LOT 272 SITE/GRADING PLAN
PATHWAYS PHASE 2

Re: Proposed Single Family Dwelling, Lot # 272 Omagaki Way, Pathways, City of Ottawa, Kollaard Associates File # 220022

With regard to structural issues only, Kollaard Associates has reviewed the following drawings:

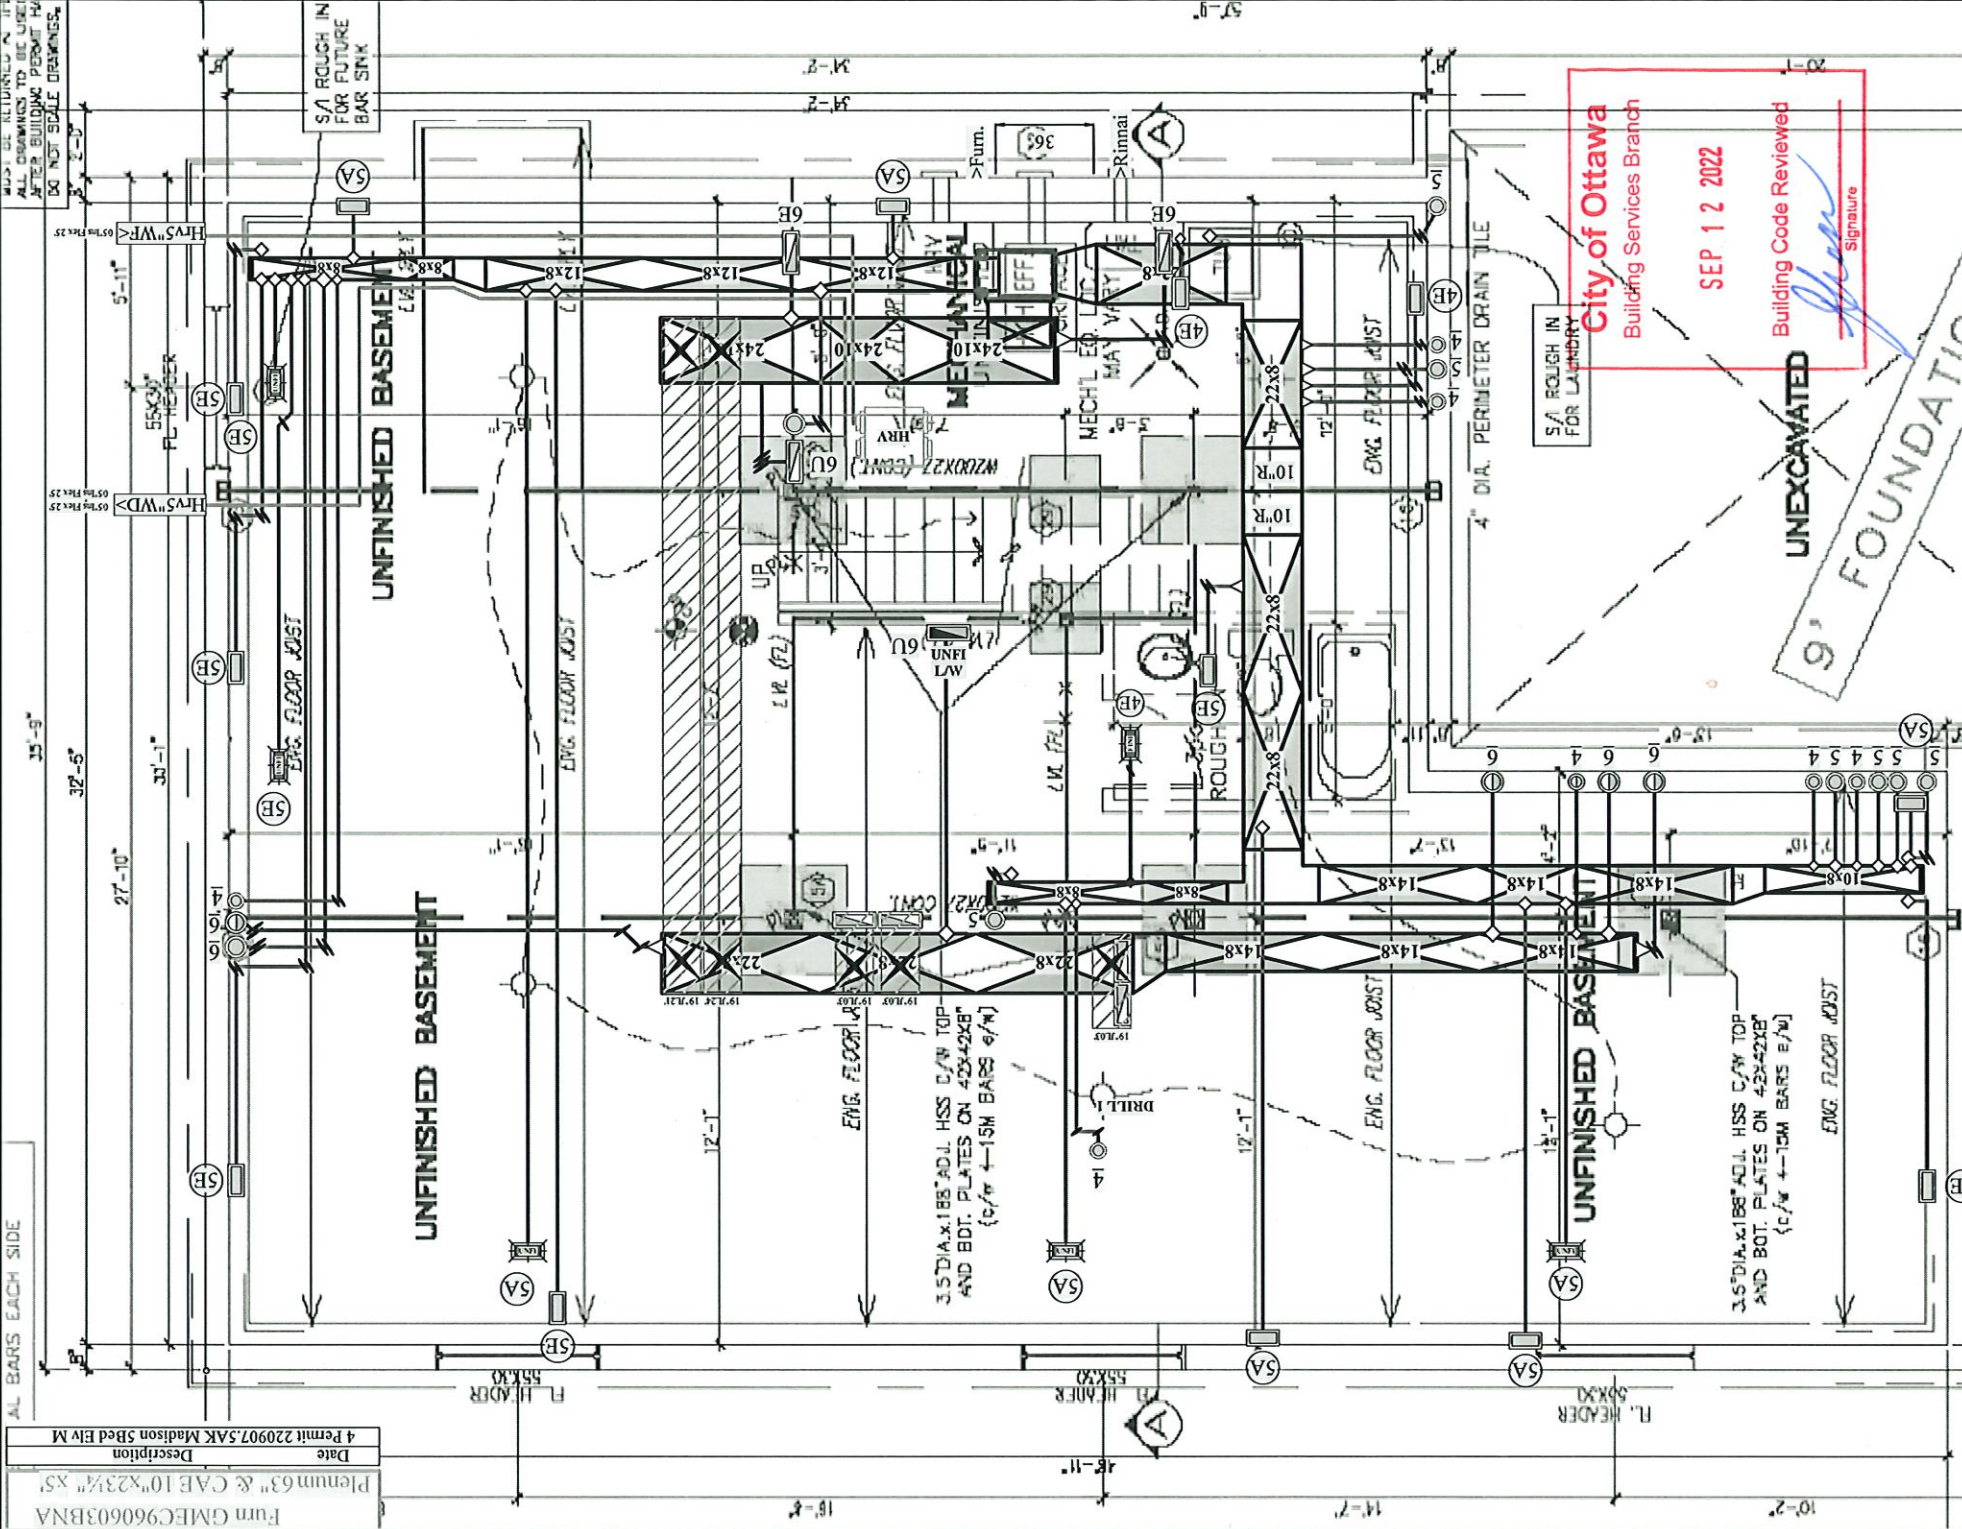
There are red notes on these plans, acceptance of the Building Permit includes acceptance of these red notes
